Historic Preservation Board

Wednesday, April 5, 2023 at 5:00 PM Via
Zoom

- i. Preliminary Review of Proposed New Construction; 58 FORE STREET (BLOCK 4) Portland Foreside Development Company, Applicants. A project and plan summary are available for viewing on the city's CSS Portal (<https://css.portlandmaine.gov/>) by referencing Plan Number HPBR-002380-2023.
- ii. Preliminary Review of Proposed New Construction; 58 FORE STREET (BLOCK 6) Portland Foreside Development Company, Applicants. A project and plan summary are available for viewing on the city's CSS Portal (<https://css.portlandmaine.gov/>) by referencing Plan Number HPBR-002391-2023.

STAFF MEMORANDUM HISTORIC PRESERVATION PROGRAM PLANNING AND URBAN DEVELOPMENT

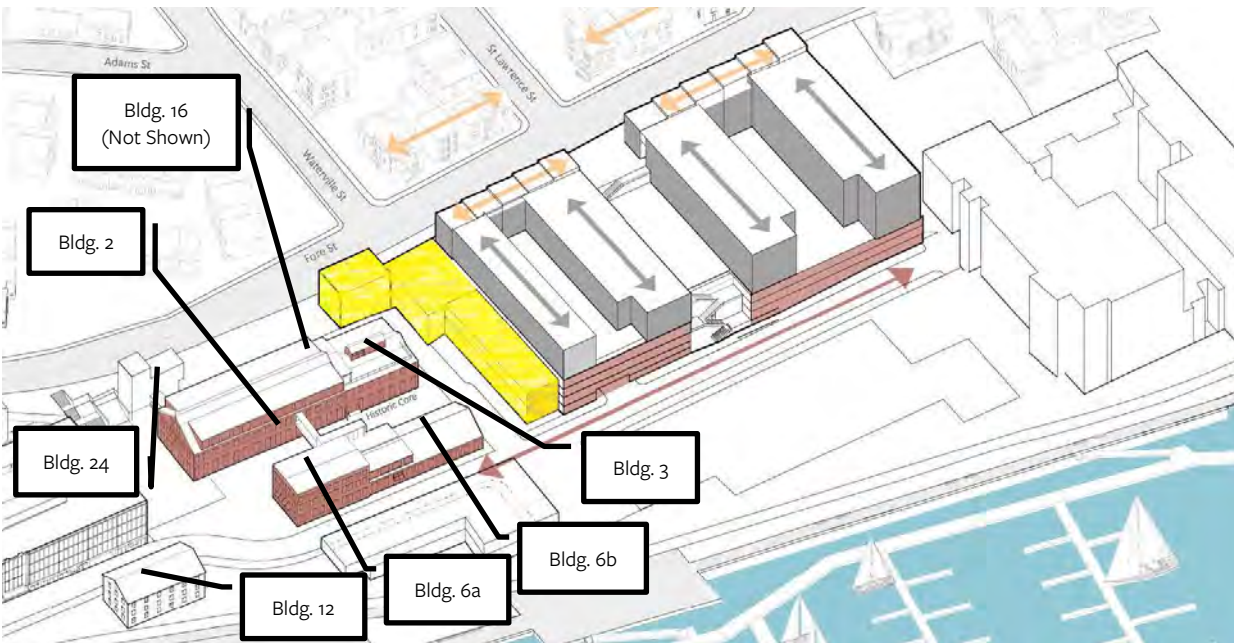
The driveway podium also stands out in contrast to the west wrapper and the townhouses in its solidity, currently being shown as a blank wall. It's unclear from the information provided whether the podium has interior programming below Fore Street and if so, what it might be. Staff would encourage the Board to discuss whether this element should be given fenestration or other articulation, or whether its blank treatment is an appropriate response to the driveway and Fore Street above.

While staff would not encourage the Board to focus on materials at this stage given that the applicant has not provided great detail on the placement and finish of any proposed materials, staff would note that brick is conspicuously absent from the portions of the buildings within the historic districts. The Board might consider questions of whether the use of brick in a clearly contemporary way might strengthen the contextuality of the structures and provide a transition from the historic structures to the much more contemporary upper stories of Block 4.

Additional information will need to be provided prior to a subsequent Board workshop so that staff can provide a fuller review, and the Board can have the information necessary to provide direction and make findings regarding contextuality and appropriateness. In addition to responses to Board comments from the March 15th workshop, staff would particularly recommend including the following in a next submission:

- Photo documentation of existing conditions including from within the district;
- A complete set of floor plans for the proposed structures within the Historic District;
- Elevation drawings focused on the proposed structures within the district showing them in relation to the various historic structures, including the smaller structures that sit below Fore Street at the north edge of the district;
- Additional renderings showing the proposed structures in relation to the historic, such as views from within the historic core and from further west on Fore Street (at present, the applicant has provided only one rendering showing any historic structures).
